Donlight Changelog 1/09/2022

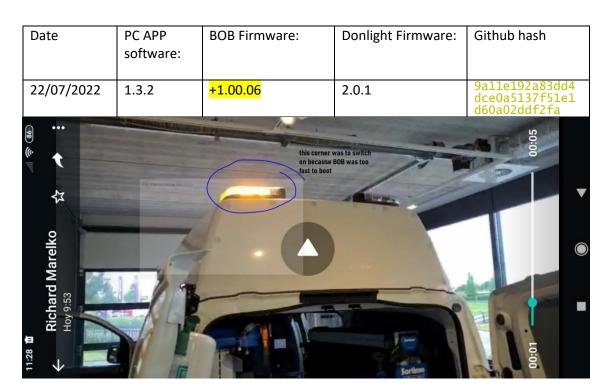
After spending 3hours with Richard at Gerderland and connecting the turning signals from the vehicle to an oscilloscope, we noticed this vehicle had a delay between turning signals of 9ms. As the BOB was set to tolerate delays up to 5ms between received turning signals the lights were glitching when the hazard was on.

$13000003500_rev01_BOB_V01_00_05_hazardelaytoleranceUpto11ms$ is build on top of v01_00_04 with increased tolerance to delay in turning signals.

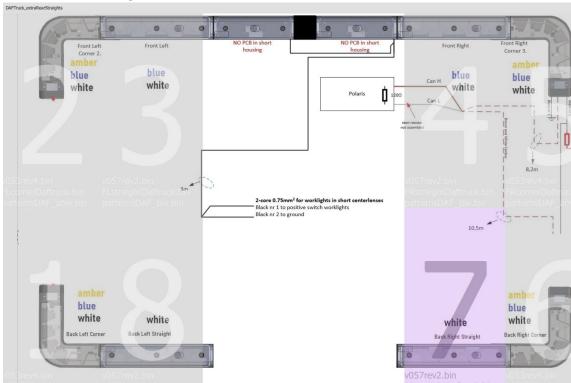
After Wesley's request:

Added DAFTruck_extraRearStraights setup, based on DAFTruck_amberbluewhite setup with two extra white straights on the rear.
